Intel[®] Atom[™] Processor E6xx Series

Specification Update

Revision 017

Document Number: 324209-017US

Figure 10. 1U Natural Convection Heatsink Mechanical Drawing

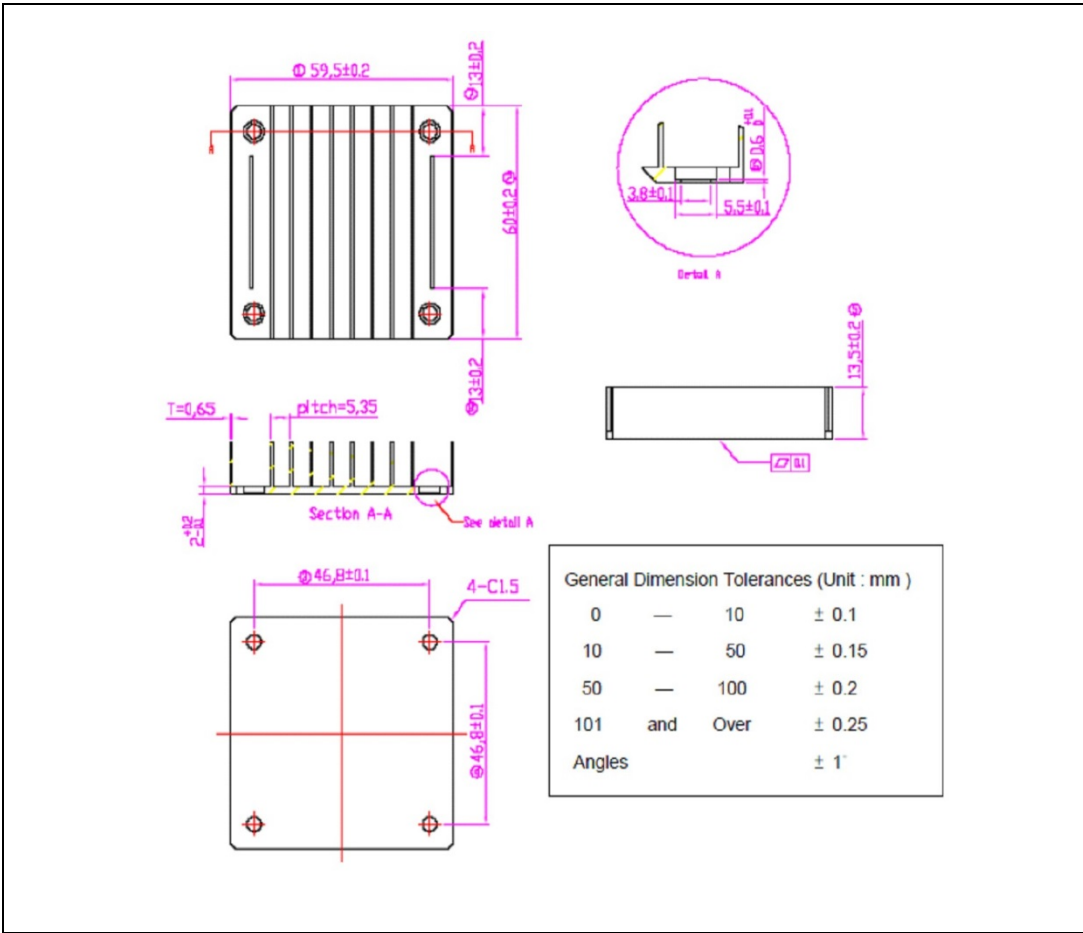
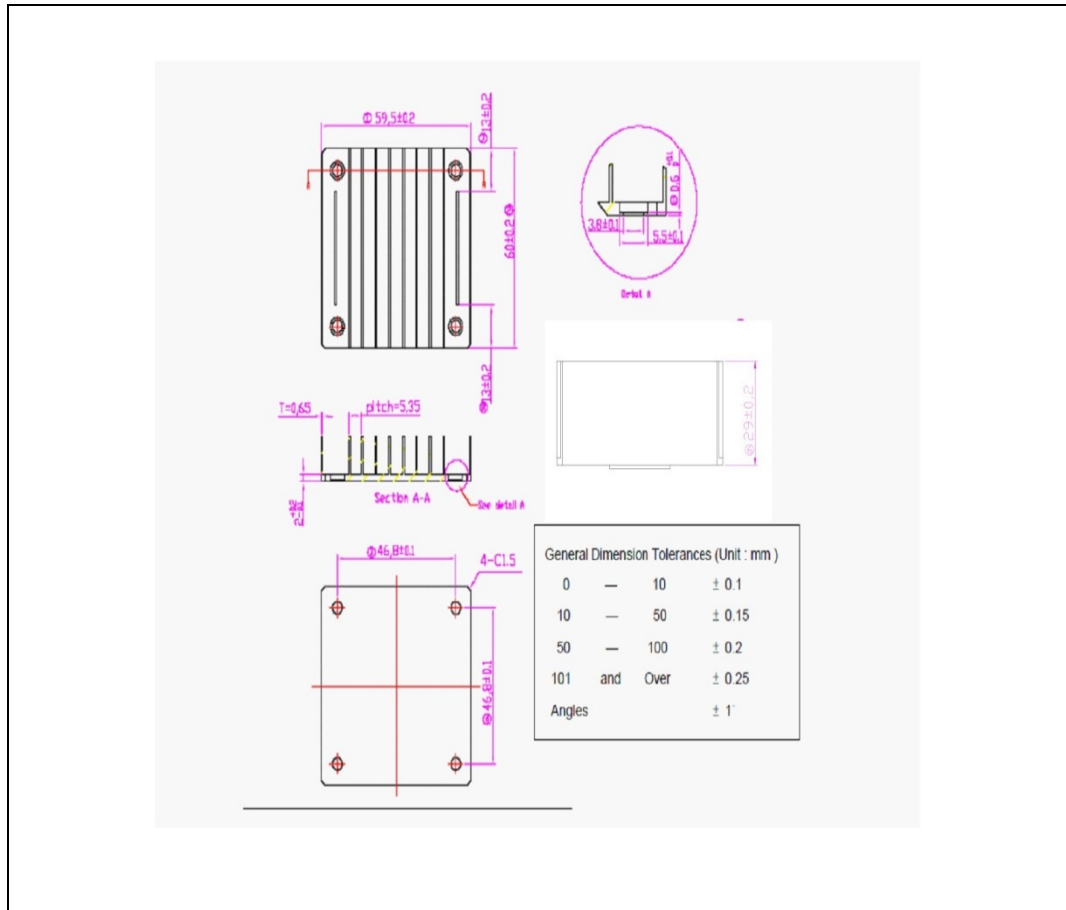
1. Heatsink Height Change

Issue: Heatsink height on Figure 10 “1U Natural Convection Heatsink Mechanical Drawing” has changed from 13.5 ±0.2 mm to 29 ±0.2 mm.

Affected Docs: Figure 10 "1U Natural Convection Heatsink Mechanical Drawing" of *Intel® Atom™ Processor E6xx Series Thermal and Mechanical Design Guidelines*, Rev 003.
